INGRAM RESIDENCE AS-BUILT DIM. 9/17/12

Drake Construction Services
Ingram Project # 4292

9/17/12
 Master Cabinet Layout

[08-08-12]
Kitchen - Wall 5

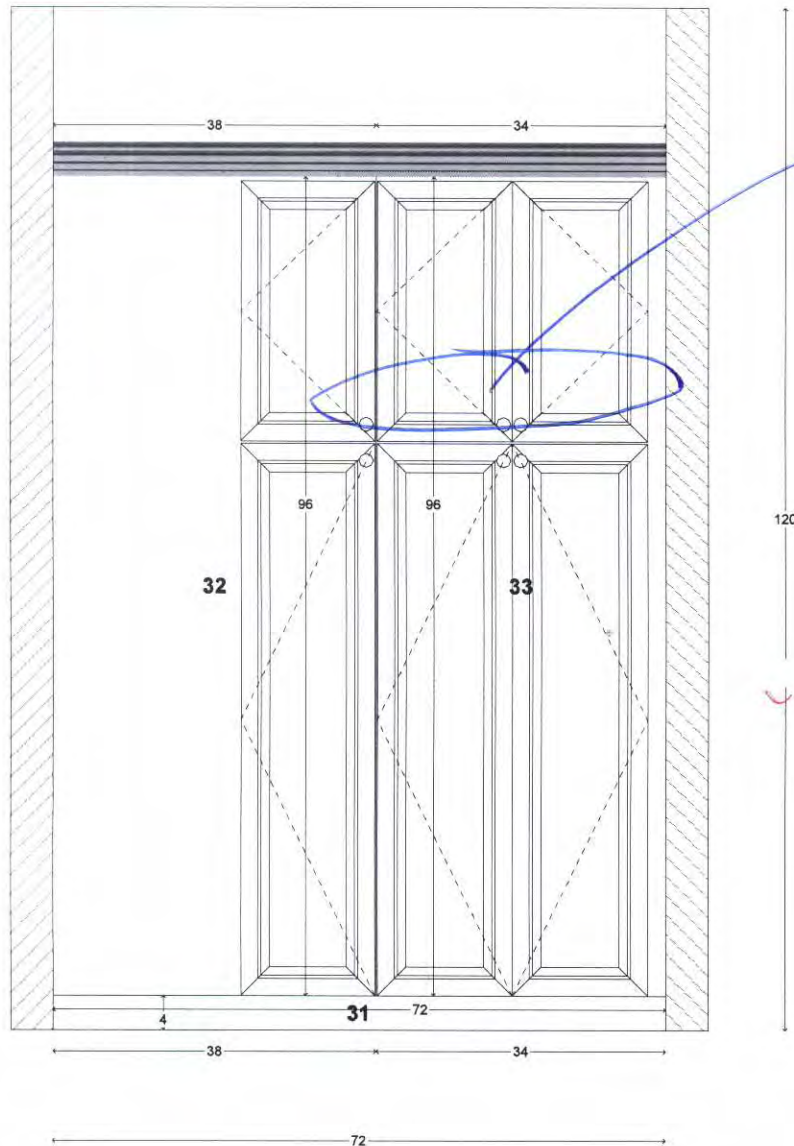
Delete
Walk-In
Pantry
Framed

[08-07-12]
 Master Bath - Wall 8

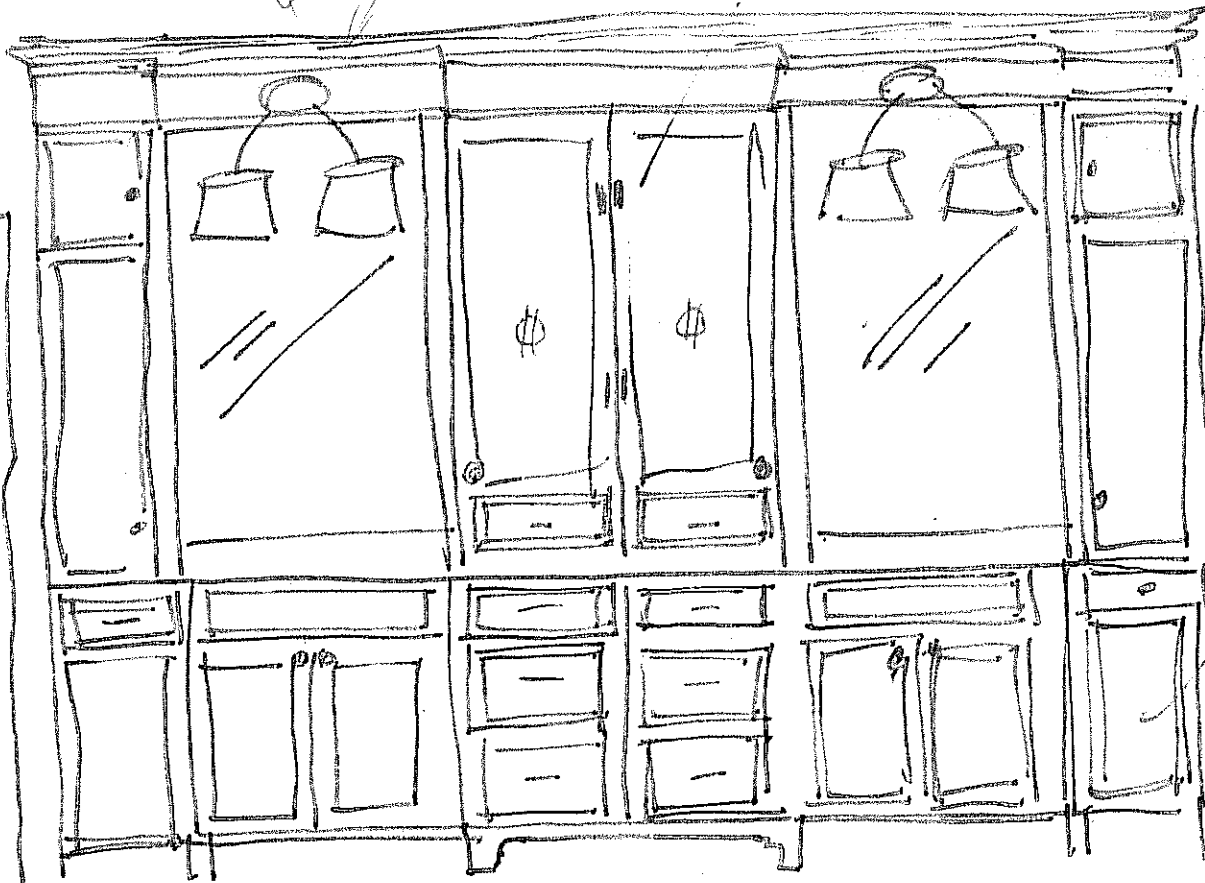
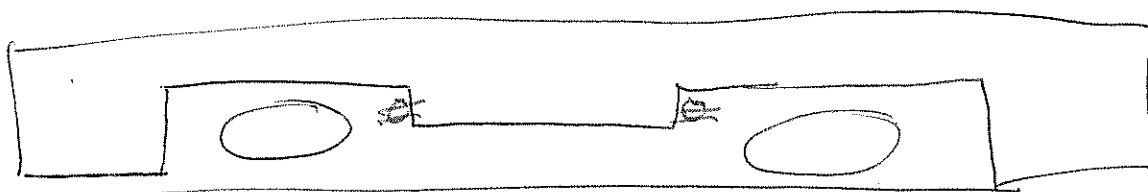
switch
seperator

APRX 80" WIRE LIGHT
STUB
FIXTURES IN FREEZE BOARD

2 HINGES

2 ENDS
FULL
DEPTH

TILT OR
ROLL OUT
HAMPER
BOTH
SIDE

ELECTRIC NOTES 9/5/12: NOTE: Revisions since 8/1/12 plan are in GREEN

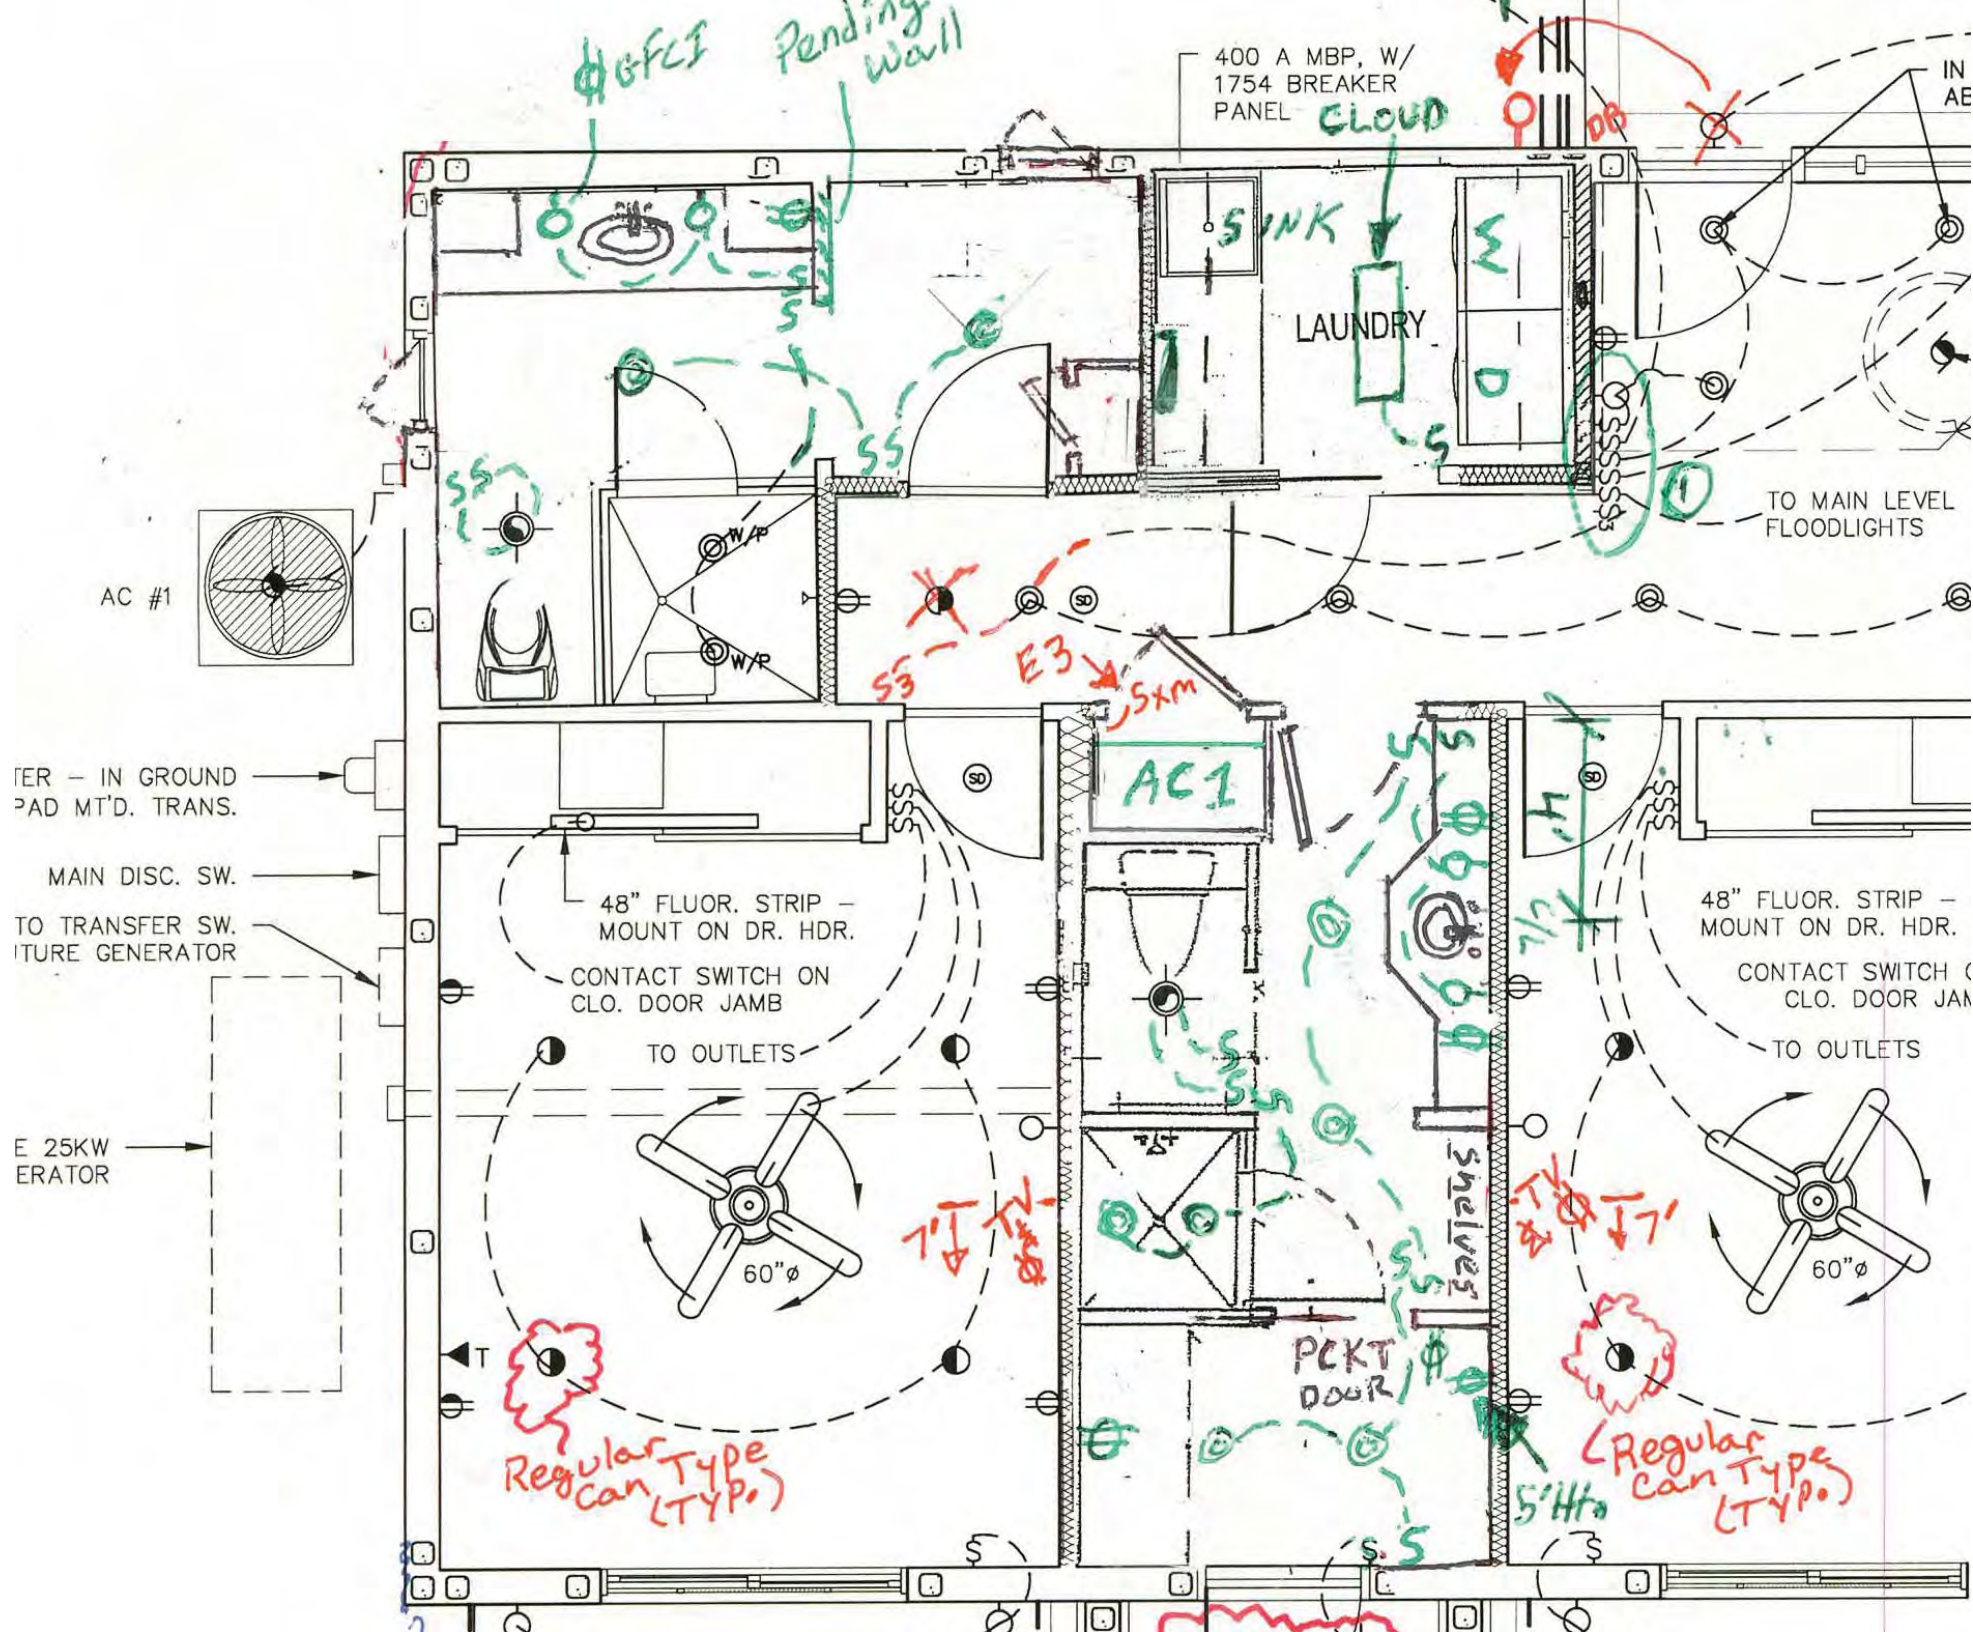
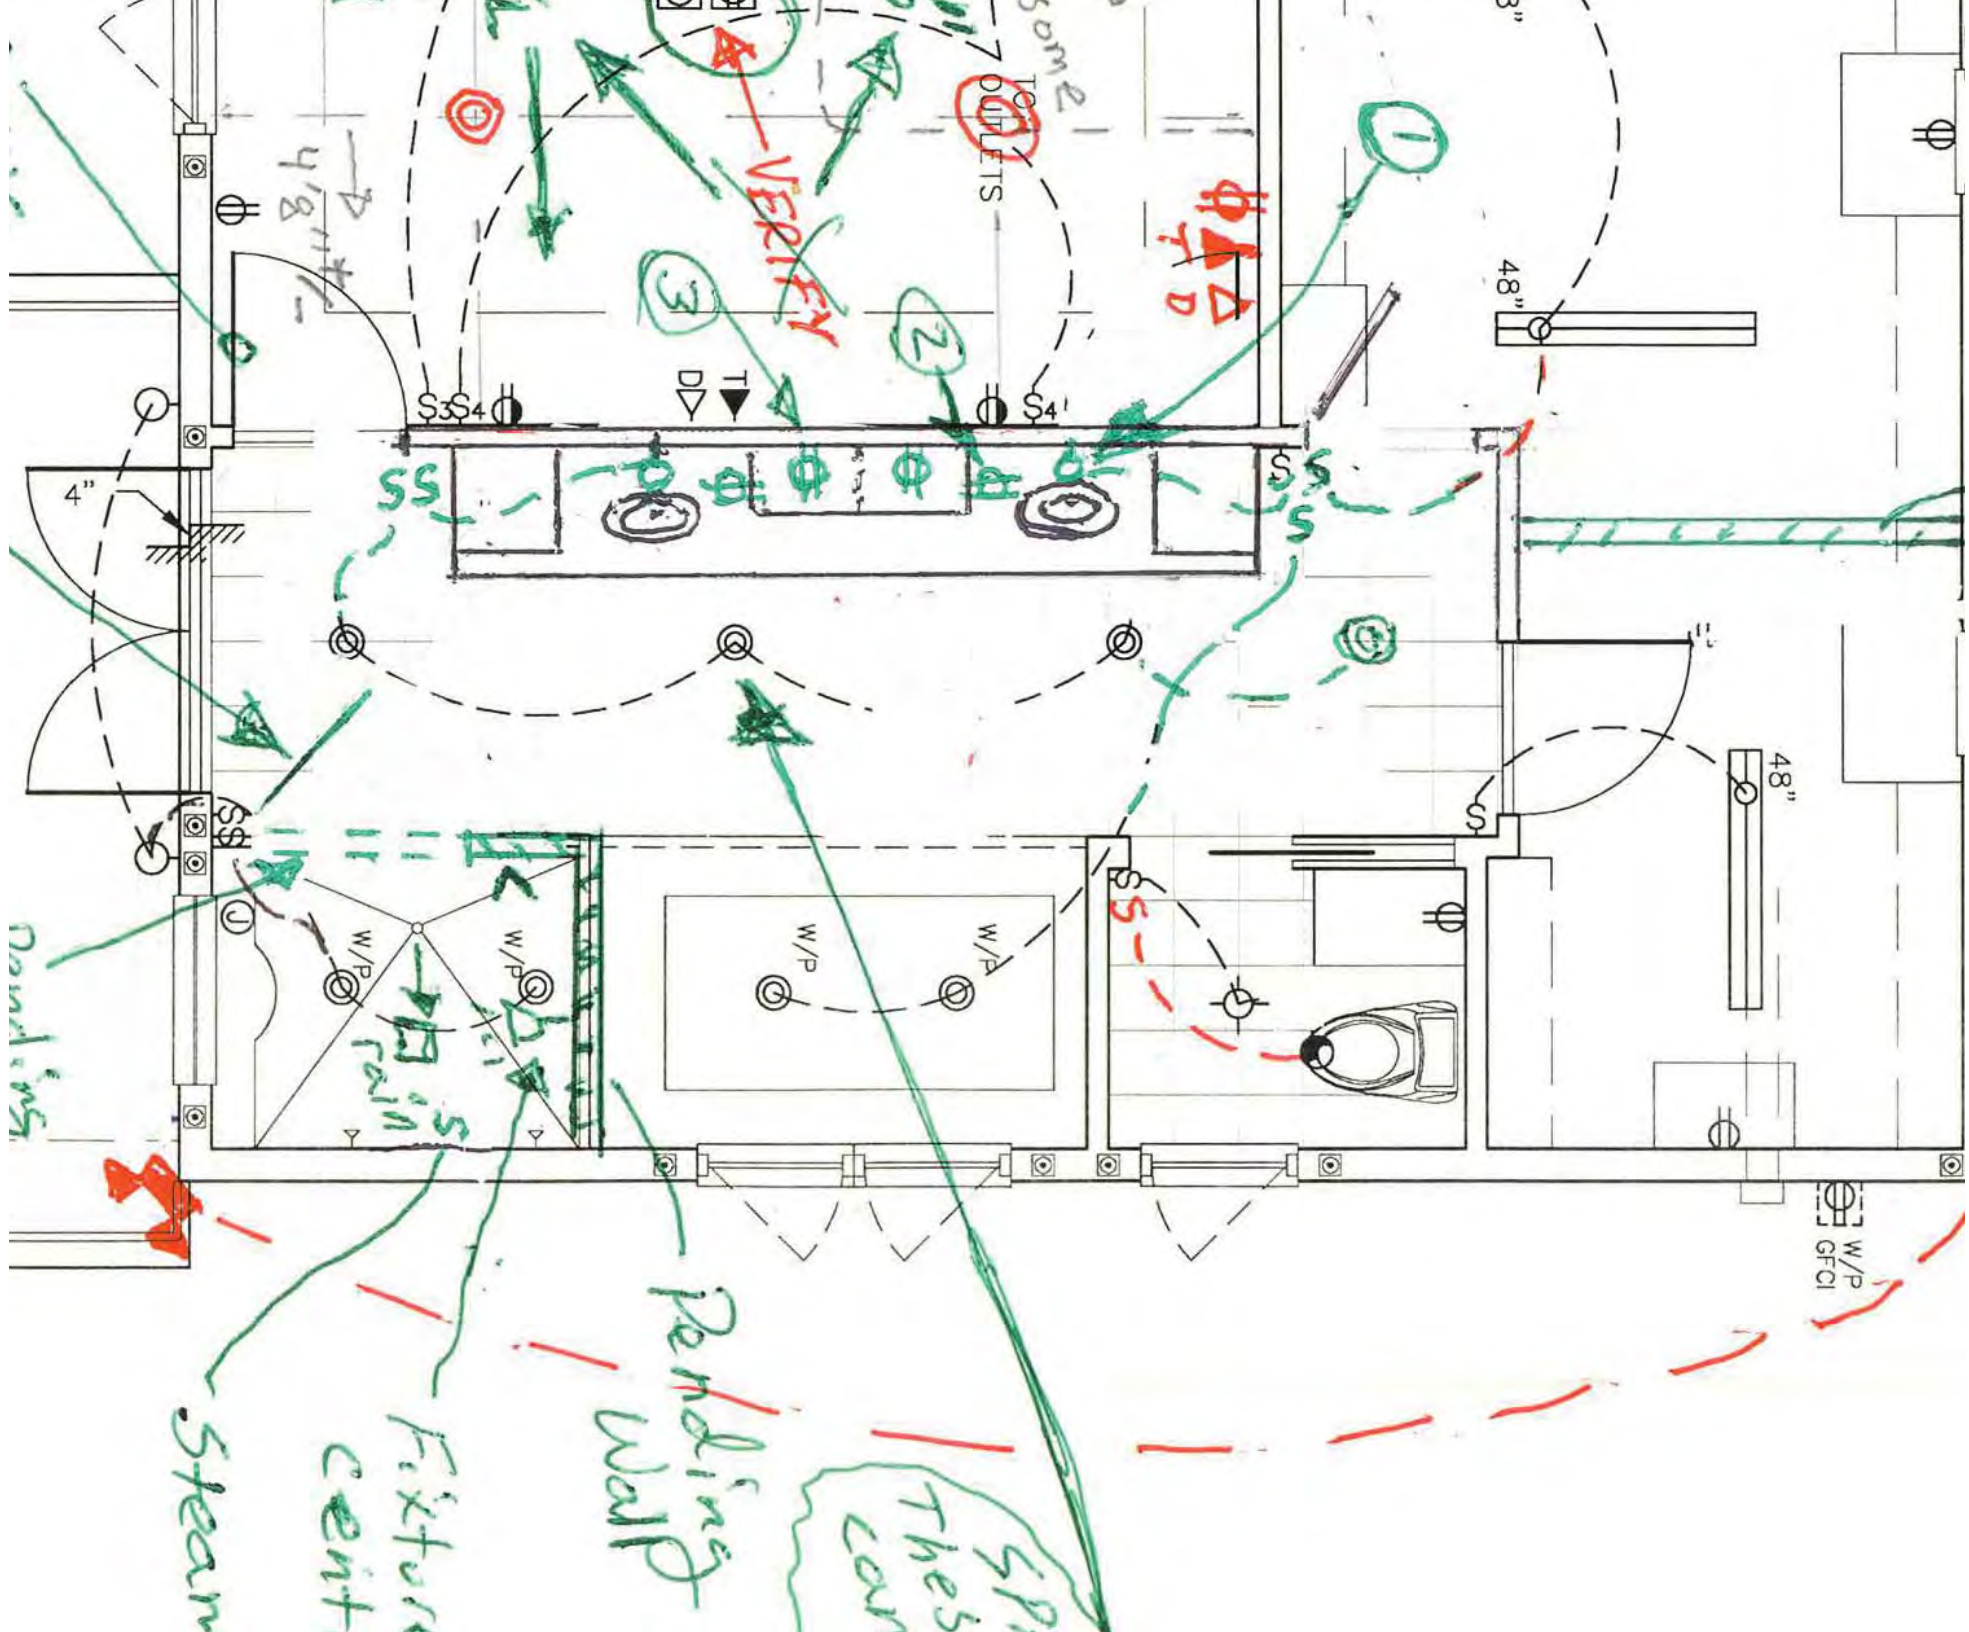
- ① SCONCES over M. Bath Sinks - stubb wire 80" up on wall. Fixtures will be installed in cabinet freeze board
- ② Outlets beside M. Bath Sinks - outlets will be installed in Center Cabinet Tower with cut in boxes. stub wires for Rough-In
- ③ Two outlets in M. Bath vanity Center Tower
